SYDNEY CBD AND SOUTH EAST LIGHT RAIL SUBMISSION NO.2 VICTOR P TAFFA

2 DECEMBER 2013

Elizabeth Street Tram Terminus Melbourne:

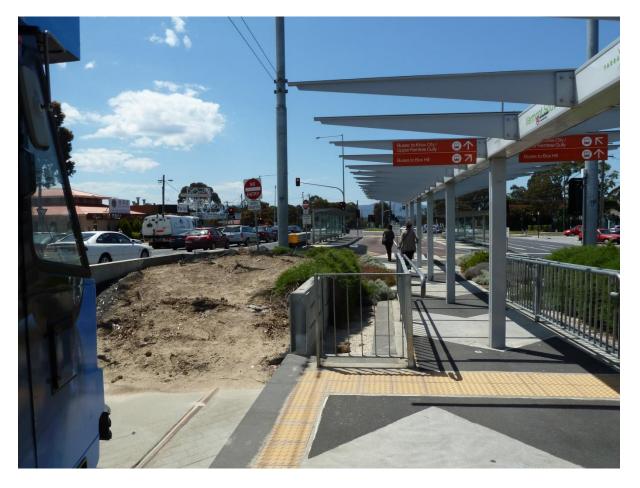
Melbourne has introduced island stops particularly in Flinders Street. One of the busiest Tram Stops is the Elizabeth Street Terminus which is an island ground level terminus serviced by Route 19 from North Coburg, Route 57 from West Maribyrnong and Route 59 from Airport West. Trams arrive and depart via a set of scissors cross over tracks and terminate in a straight line. The Elizabeth Street Tram Terminus is named after Sir Robert Ristrom who saved the Melbourne Tram Network from going the same way of many Tram Networks including that of the Sydney Network into extinction.
